VILLAGE OF COTTAGE GROVE
MEETING

AD HOC ARCHITECTURAL REVIEW COMMITTEE

RE: **Comfort Suites Hotel – Precise Implementation Plan**

**Proposed Comfort Suites Hotel: Greywolf****REVIEW COMMENTS**

Brand
COMFORT SUITES
Description
ESTATE MONUMENTS

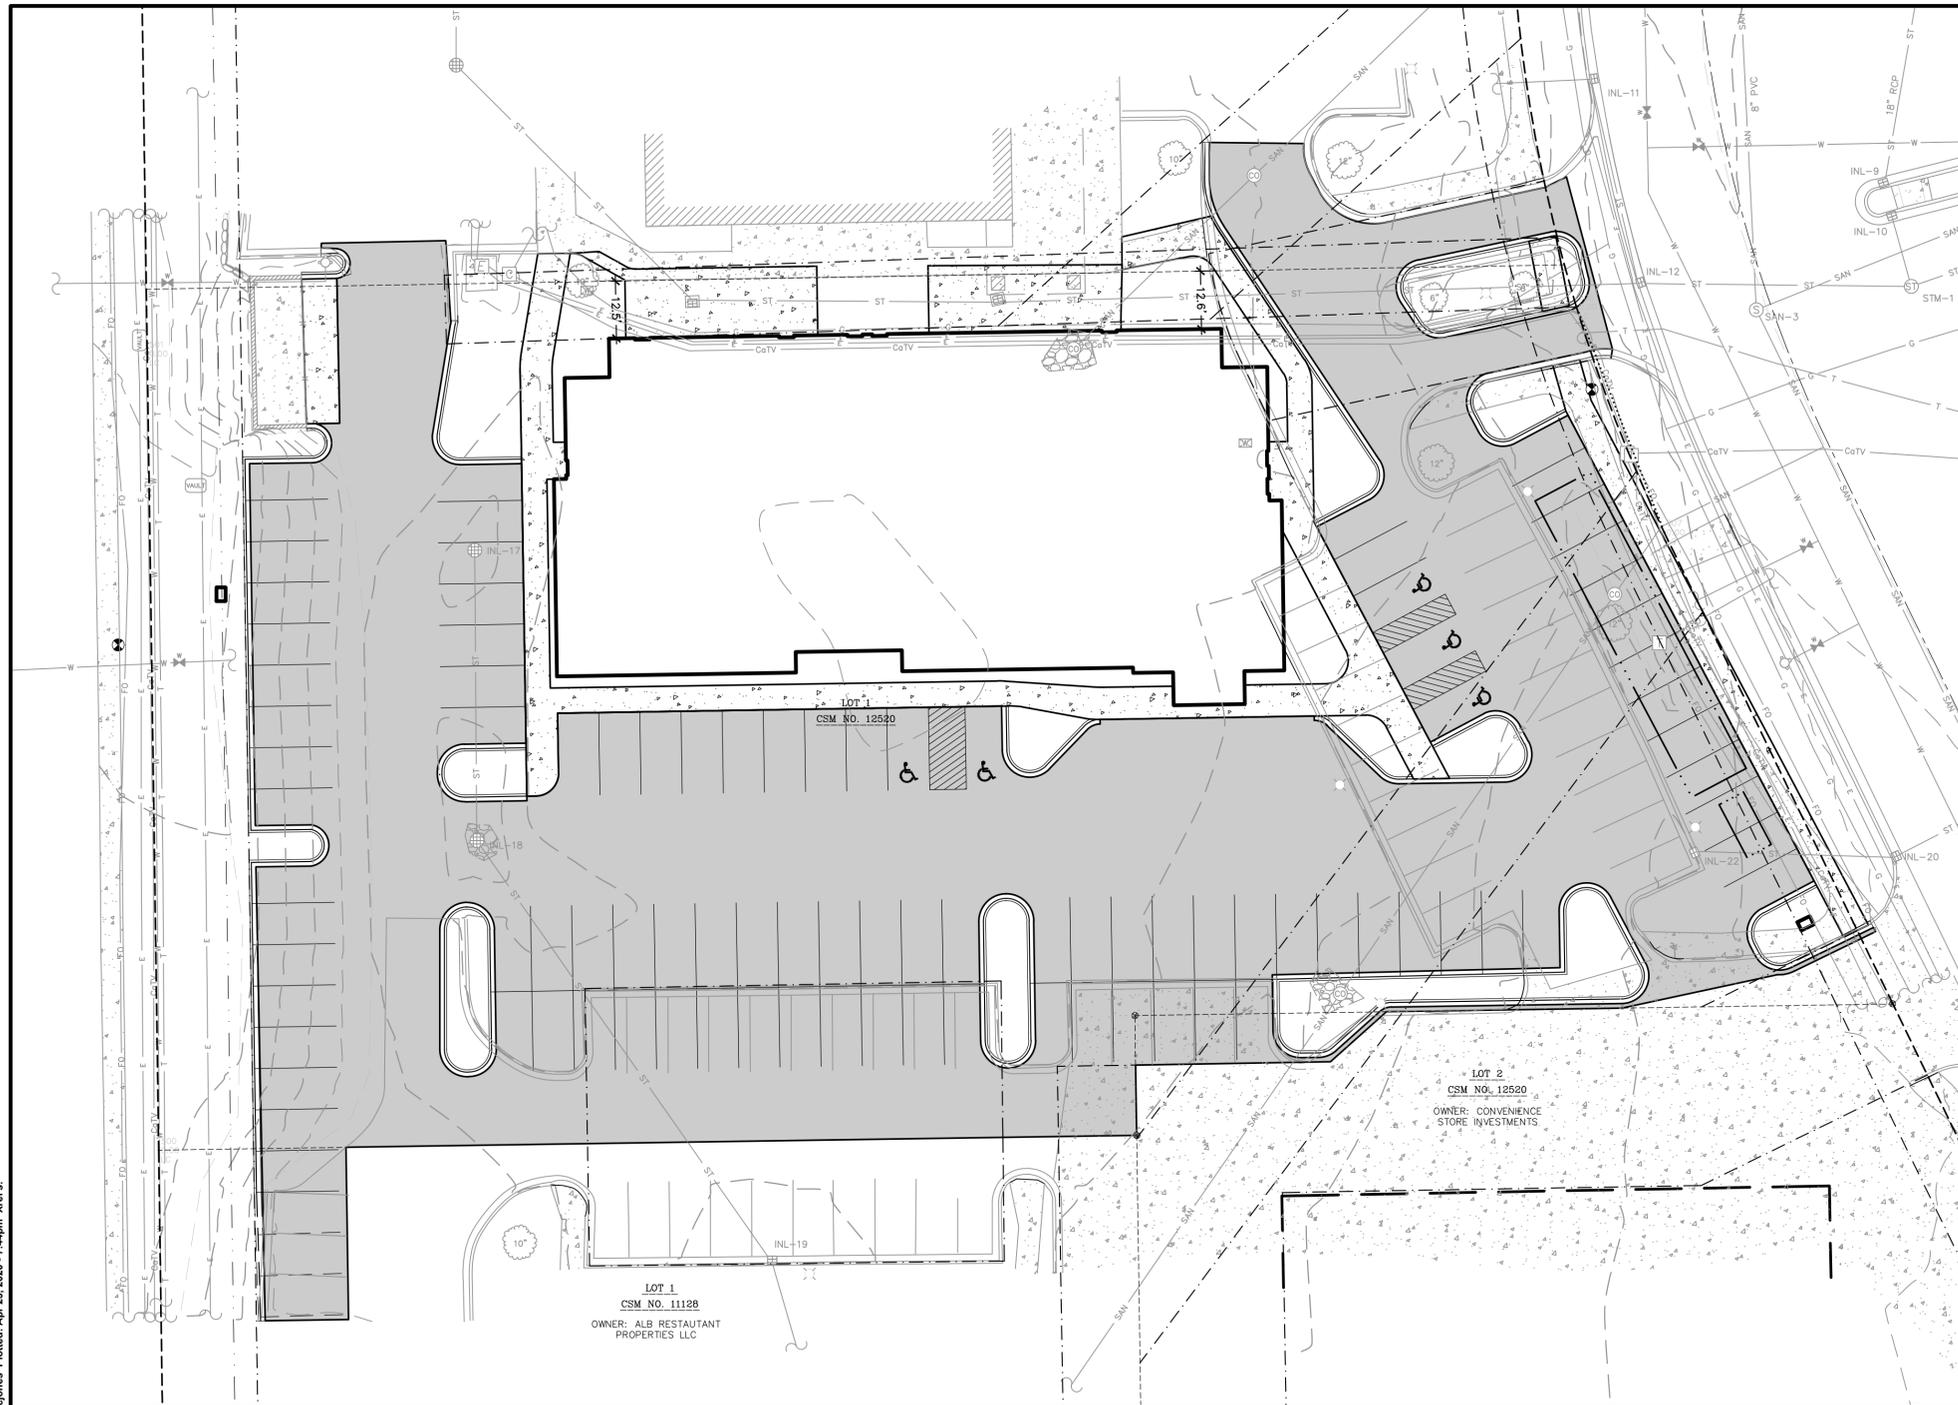
1. The sign details show three monument signs for the site. First the sign locations should be identified on the plan. I believe I am seeing two of the locations but cannot determine the third location.
2. The Village Ordinance 325-106 C(1)(a)[2][a] states a total number of freestanding signs in the zoning district is one where it appears three are proposed.
3. The Village Ordinance 325-106 C(1)(a)[2][g] states a monument sign should be placed outside of the rear building setback which is shown as 30 feet on the submittal. I am assuming the one location shown is along the rear line of the property that abuts CTH N.
